ARCHITECT'S SUPPLEMENTAL INSTRUCTIONS

Date Issued:	August 13, 2021
Project:	Northpointe Medical Park- Labcorp- TI Building-'C'- Level 2 2326 North 400 East Tooele, UT, 84074
Architect's Supplemental Instructions:	ASI #1
To:	Saunders Construction 1113 South 500 West Bountiful, Utah 84010

Subject: Plan Review Response "**Northpointe Medical- Labcorp T.I.**" located at "Building 'C'- Level 2, 2326 North 400 East- Tooele UT 84074". Tooele City #: P21-421 (WC3 Project # 221-524-010)

Code Review Comments:

Figure 1

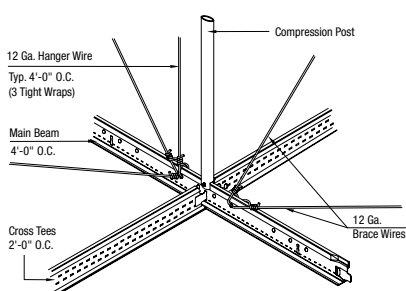
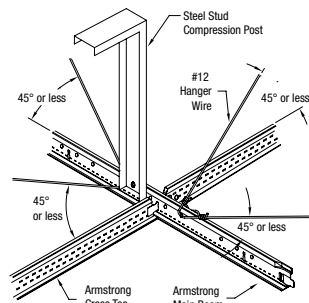
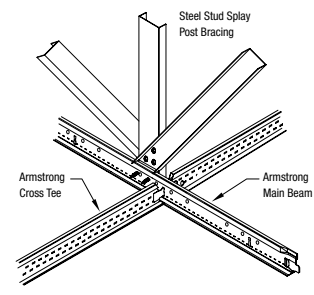
Comment A5: Sheet A503A: Detail 7 shows the seismic bracing attached to the cross runner. The bracing should all be attached to the main runner. Please address.

Response: Detail 7 on sheet A503A shows the seismic compression bracing attached to main runner. The detail is prepared in coordination with Armstrong ceiling suspension system, please see attached seismic installation manual from Armstrong.

1 Typical Mounting Heights
SCALE: 3/8" = 1'-0"

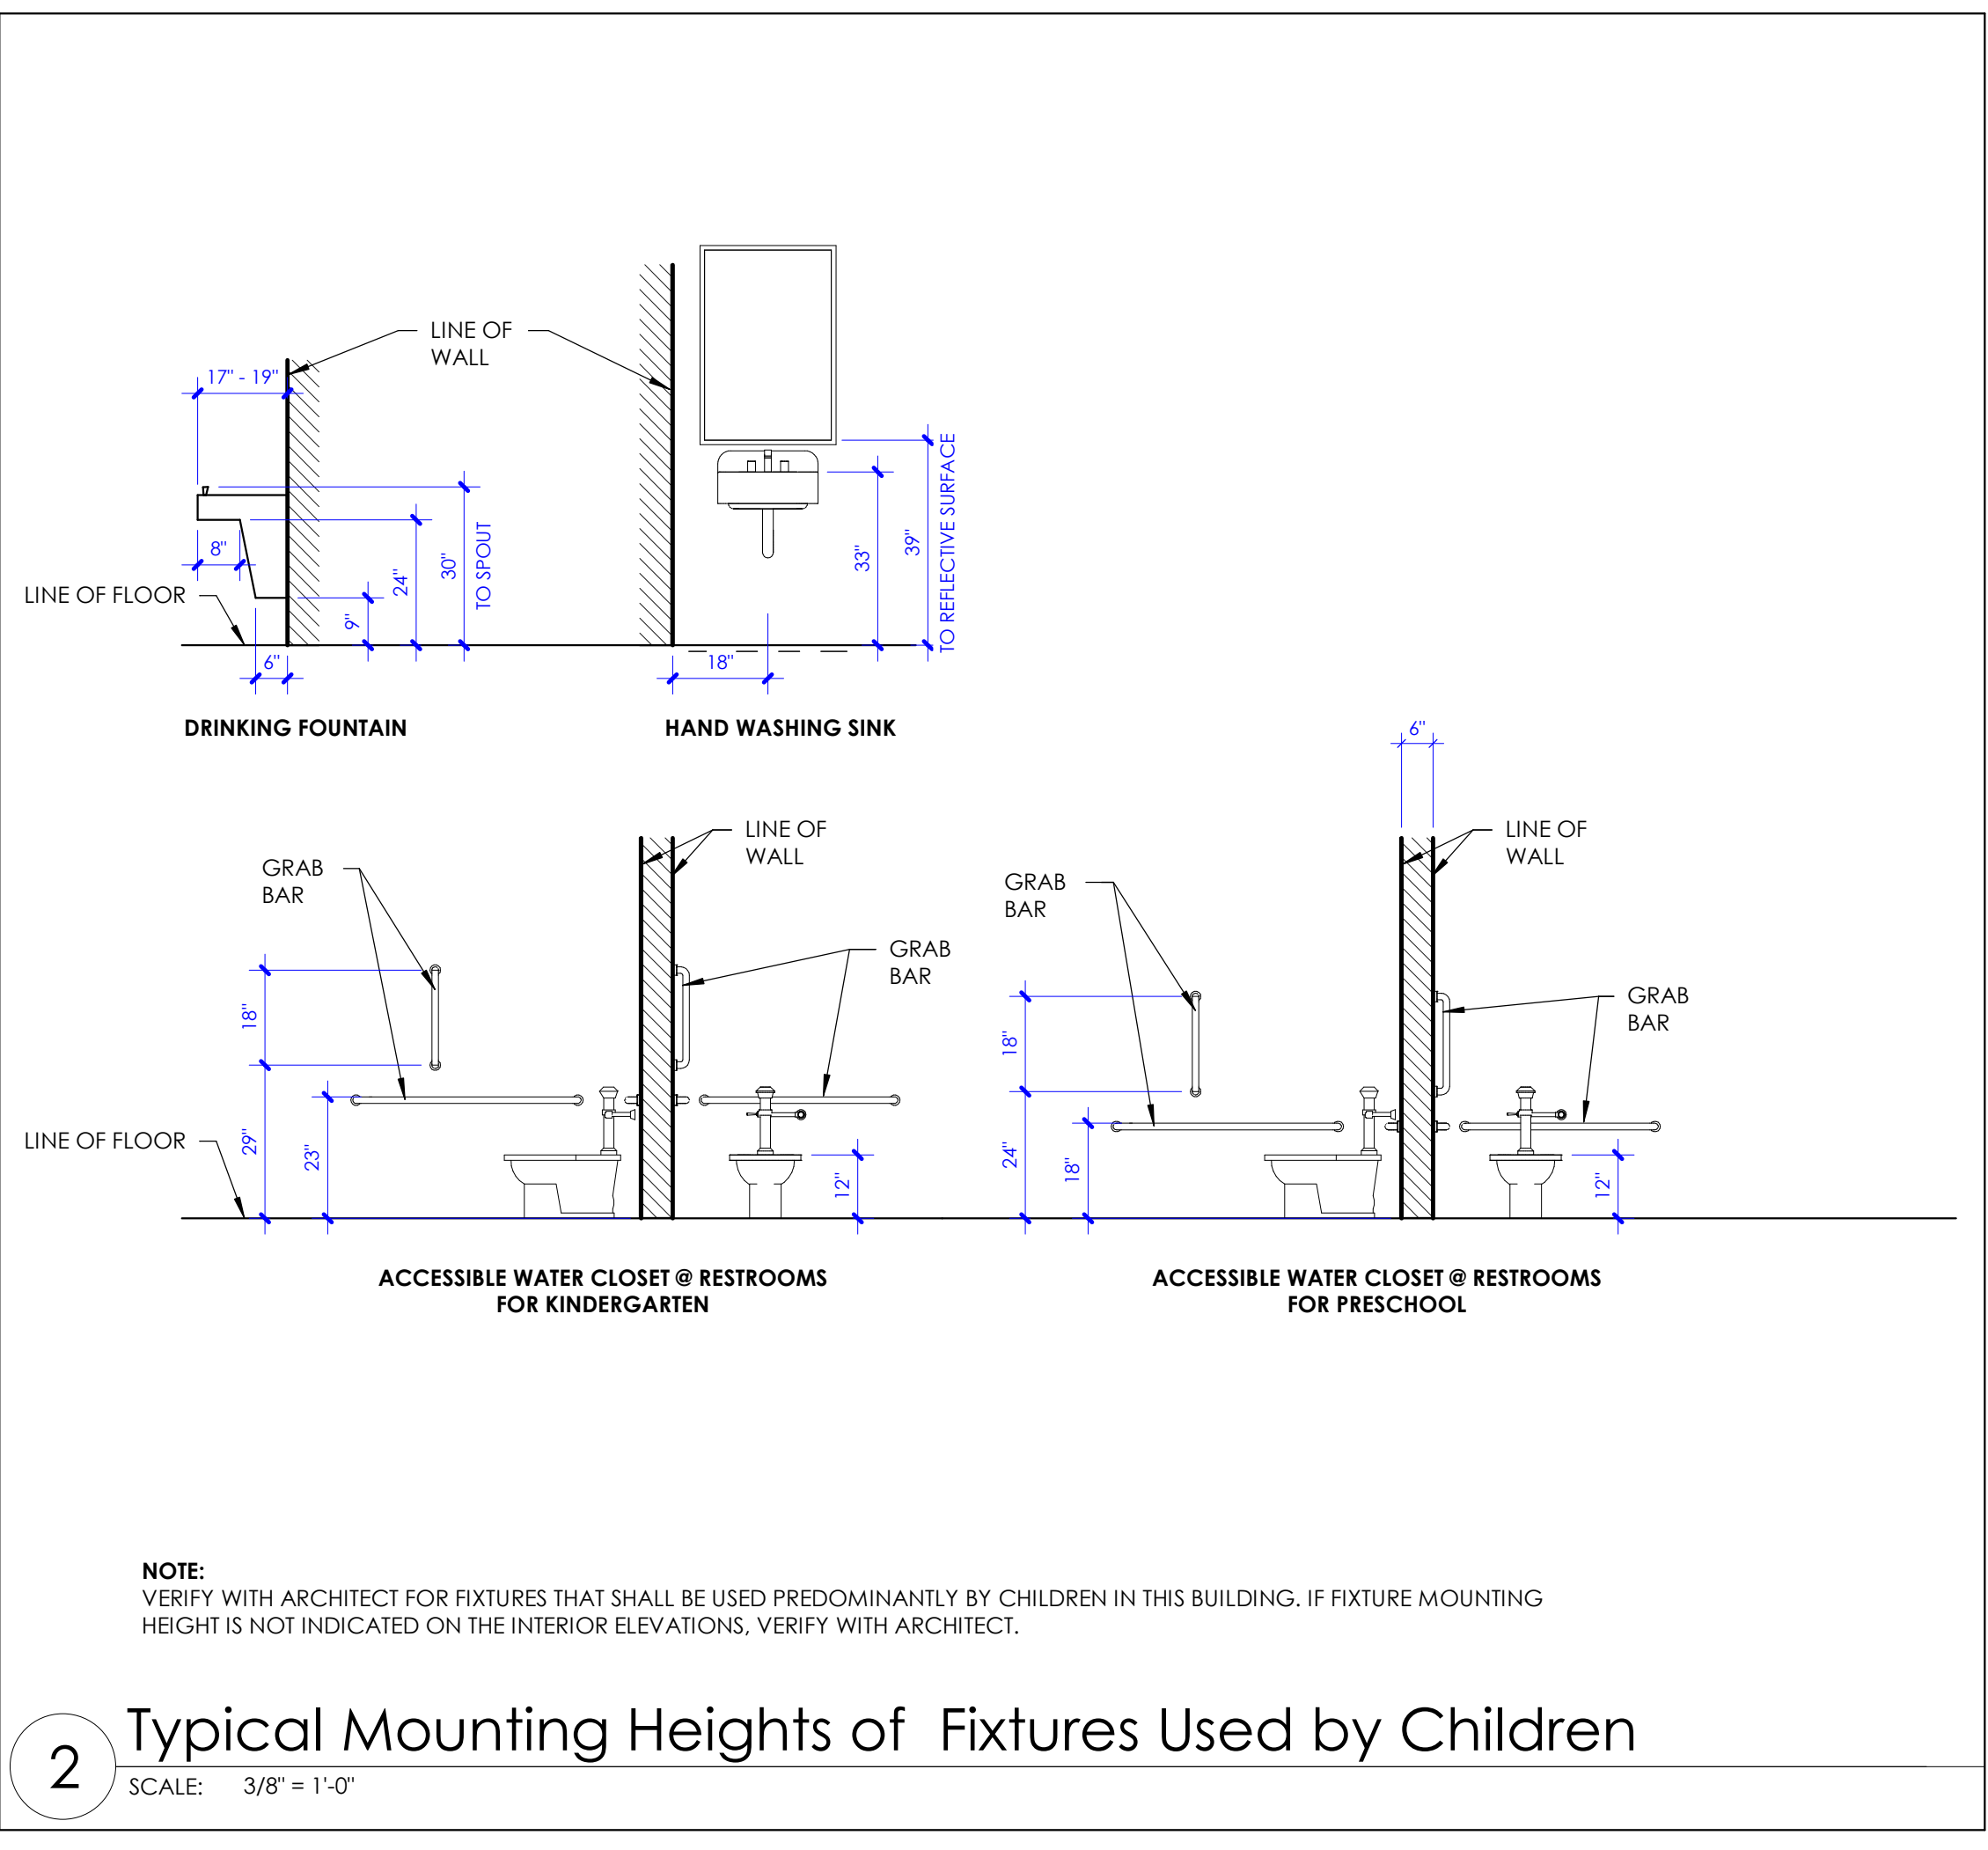
A. Detail 1 has information for the installation of med gas outlets. Please address the following:

I. No information has been provided for the installation of the med gas equipment. Please provide information noting the type, quantity, and location of all med gas in addition to how much will be in use and how much will be stored and show that the maximum allowable quantities of IBC Table 307.1(1) have not been exceeded.

II. Provide sufficient information on the plans to show how the requirements of IBC 427 have been met.

Response: Sheet G003 is a generic sheet in our set. No medgas connections required in the scope of this project. Medgas item from detail 1 has been removed. See attached sheet G003 for more information.

Response: No medgas connections required in the scope of this project. Medgas item from detail 1 has been removed. See attached sheet G003 for more information.
